UNITED STATES PATENT AND TRADEMARK OFFICE

Office Action Summary

10/549,675

WIDMER ET AL.

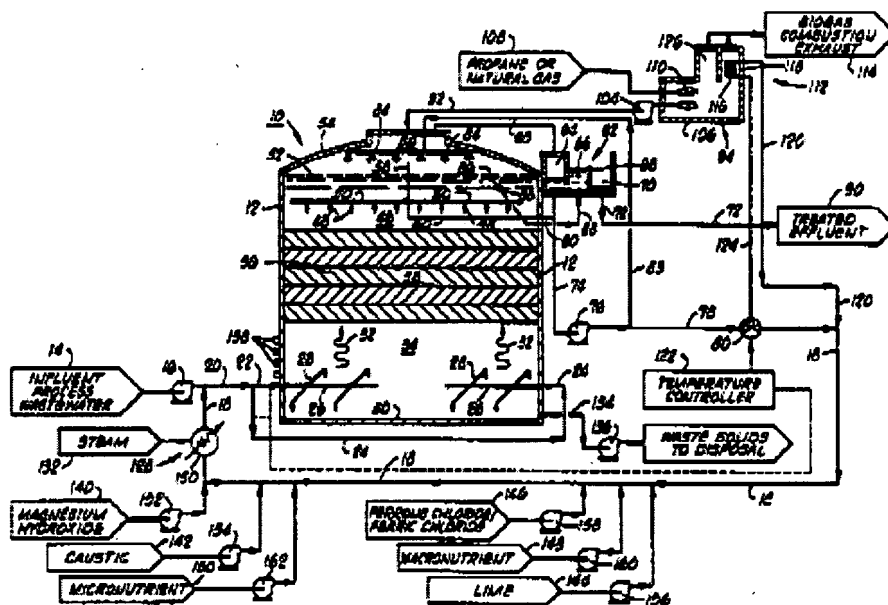
Claims 20-21 are rejected under 35 U.S.C. 103(a) as being obvious over USP 5228995 to Stover and DE 196 10 056. Stover (shown below) describes a waste water treatment reactor having means for generating biogas which upflows through the bed, and scum removal means described at col 2 lines 54-56 and col 10 lines 61-63. The statement of intended use, i.e., to be used in performing the claim 1 invention, was carefully considered, but found upon such careful consideration to be non-limiting of the

structure of the claimed apparatus. The claim is directed to an apparatus, not a method of use thereof.

DE 196 10 056 describes injection of air into a biogas-generating bed bioreactor. It would have been obvious to have done so for the reasons given in DE 196 10 056 for doing so.
